Agenda Item 10.5

To Honorable Mayor and City Council:

We thank you for the opportunity to hear our appeal of the decision to approve the 1212-1224 Winchester Hotel Project. We are sympathetic to the position you are in having to consider the complexity of the current situation. We are grateful to our District 1 Councilmember Vice Mayor Jones for all the hours he has spent listening to us and being supportive of our efforts as citizens and residents of the Hamann Park neighborhood.

We are appealing the Winchester Hotel Plan as inconsistent with what was clearly written in the Winchester Urban Village Plan.

FIGURE 3-1: LAND USE MAP

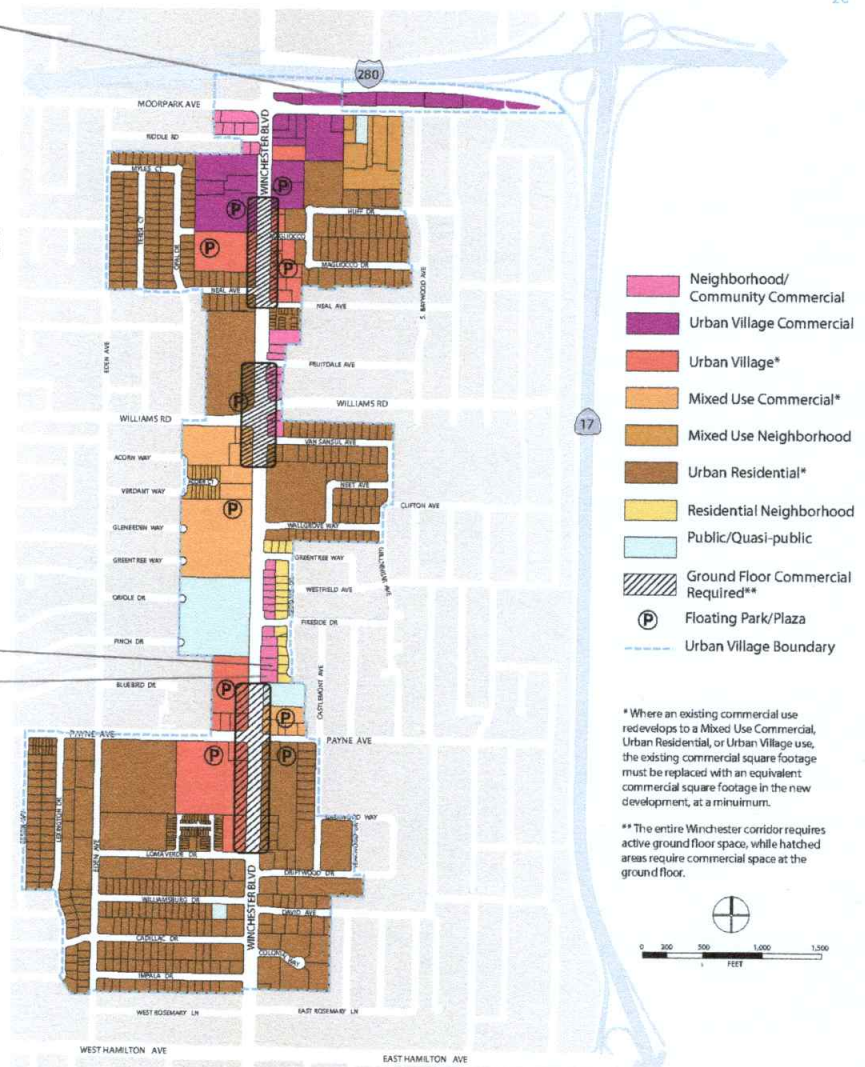
The Winchester Urban Village Plan: hotels are an appropriate use in Urban Village Commercial Land Use

Urban Village Commercial
(Appropriate for hotels per
Winchester Urban Village Plan)

1212 S. Winchester
1224 S. Winchester
(Appropriate for smaller
commercial businesses per
Winchester Urban Village Plan)

Nearby properties with marked Fire Lanes:

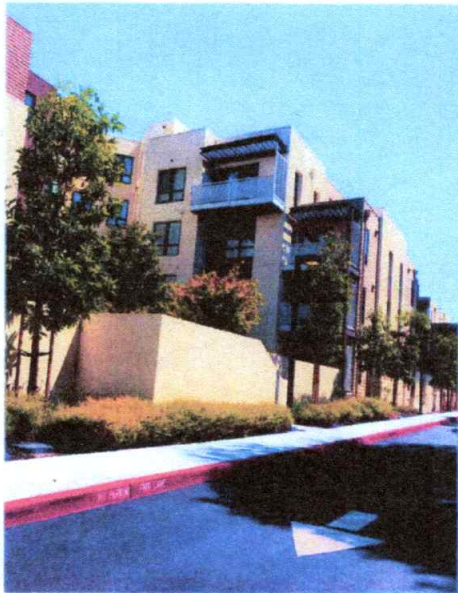
We remember the Santana Row Fire
The Hotel Plan "Fire Layout" (C5.0):
HOSE PATHS in place of side/rear FIRE LANES

Project was approved without an approved Variance...
WHY WAS THIS REVERSED?

Photos from the Front Cover of Winchester Boulevard Urban Village Plan

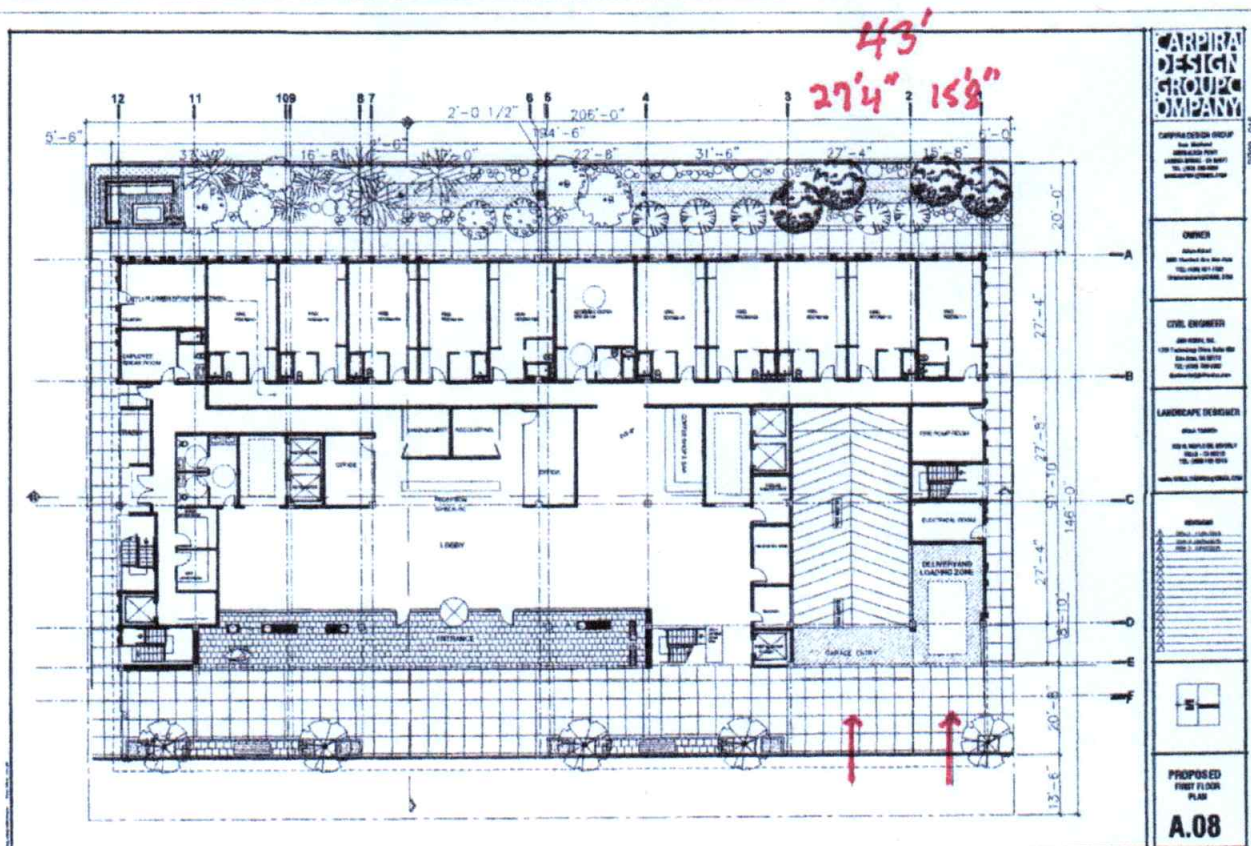
ADJACENT HOTEL DRIVEWAYS SPANNING 43' WIDE DO NOT ENHANCE THE PEDESTRIAN AND BICYCLE ENVIRONMENT

Hotel Plan Garage driveway could block the sidewalk warning signals recommended

Winchester Hotel Plan, REV-3, 02/01/21

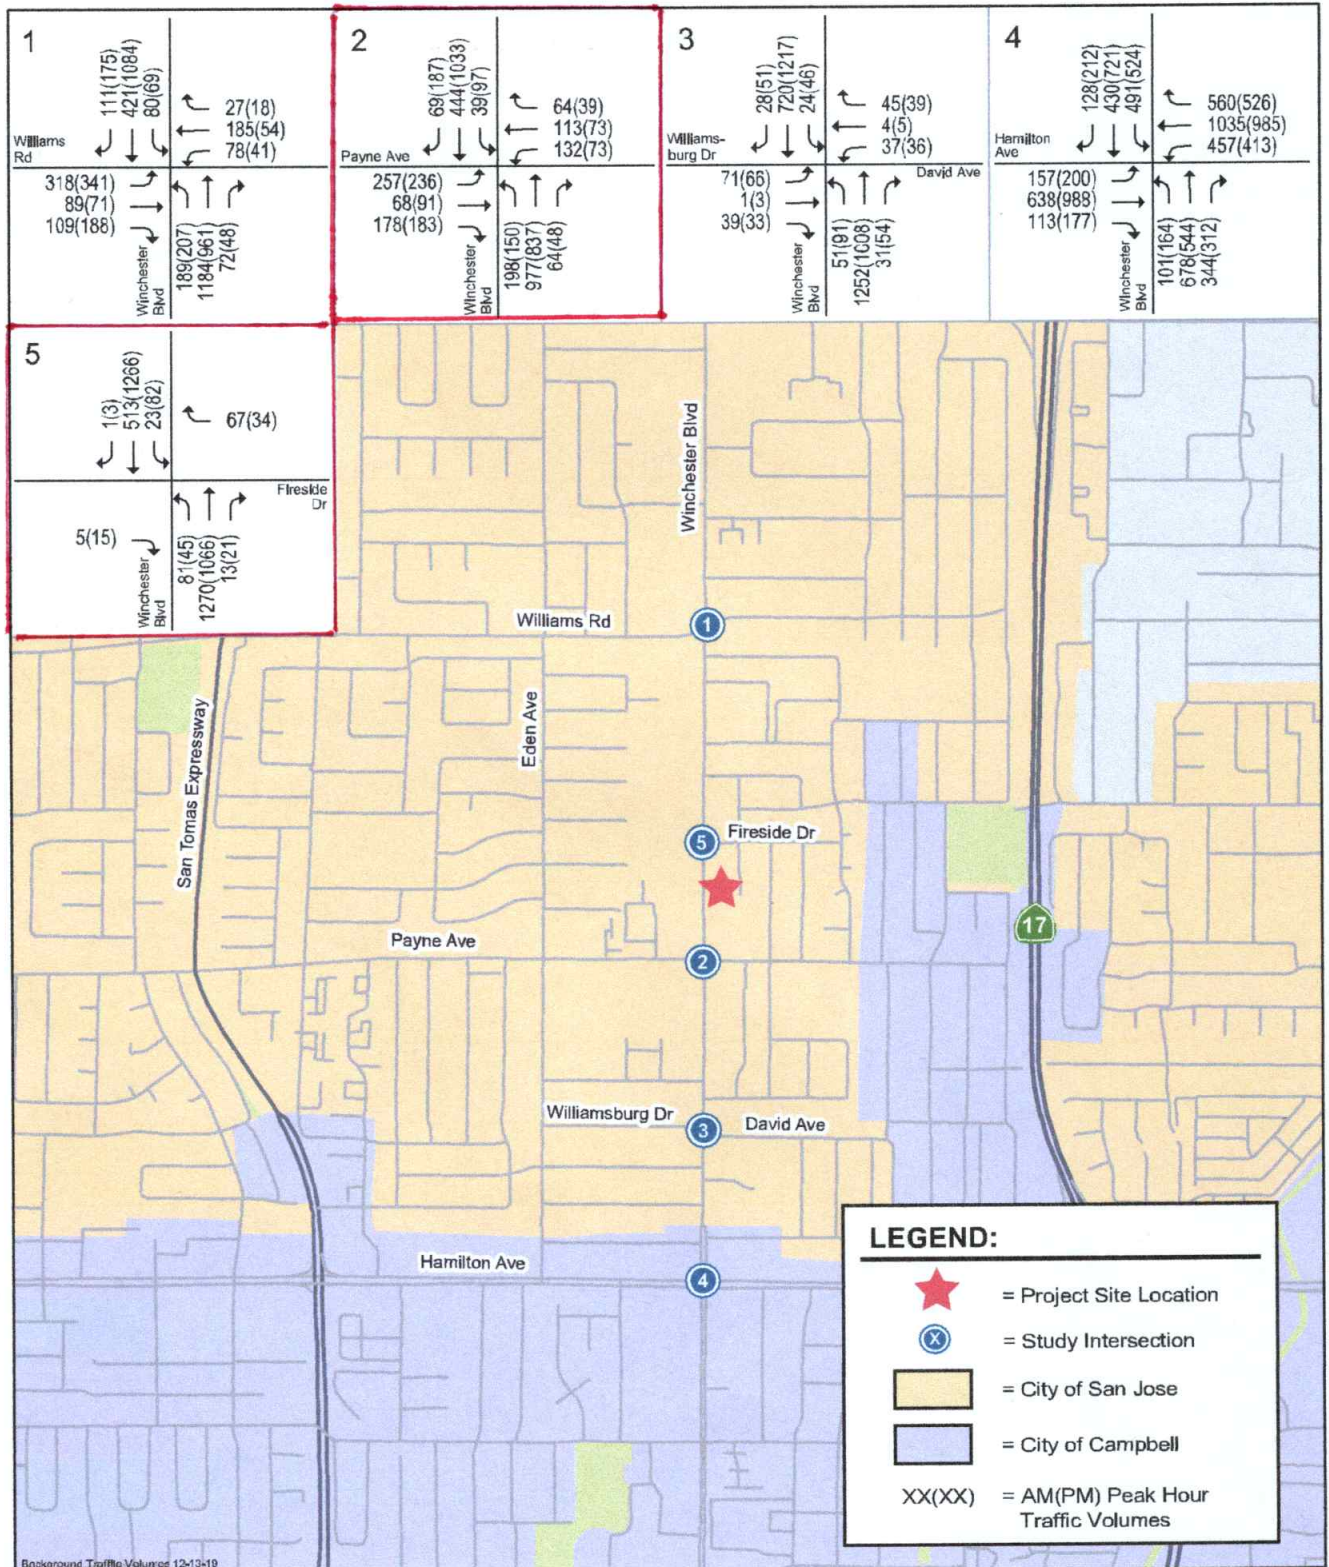
Hexagon Transportation Analysis SHOULD HAVE BEEN UPDATED to assess the impact of the revised Hotel Plan (REV-3; 02.01.21) on Pedestrian/Bicyclist Safety

- 1) Delivery and Loading Zone moved from the street to the first floor of the hotel with a 15'8" wide driveway adjacent to the garage driveway. (Hotel Plan, Rev-3, A.08)
- 2) Passenger Pick-up/Drop-Off Operations: moved from the street to the garage. "All guests will proceed to the parking garage for hotel check-in to the parking garage for hotel check-in." (Aug 4 Memorandum, p14)
- 3) "...passenger pick-up/drop off for ride share vehicles and taxis will occur inside the garage." (Aug 4 Memorandum, p14)
- 4) Adjacent garage and Delivery Zone driveways are 43' wide across the sidewalk. (Hotel Plan, Rev-3, A.08)

Figure 19
Cadillac Residential Parking Program

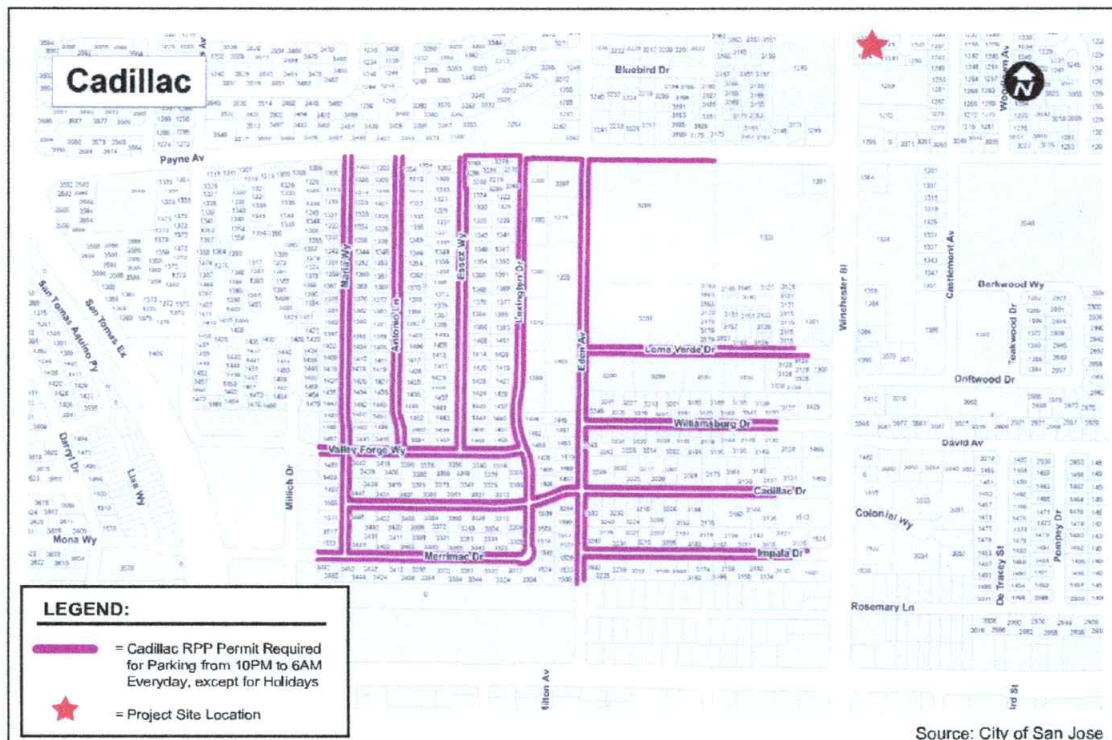
1. Was this requirement met?
2. Where is the site for the replacement parking
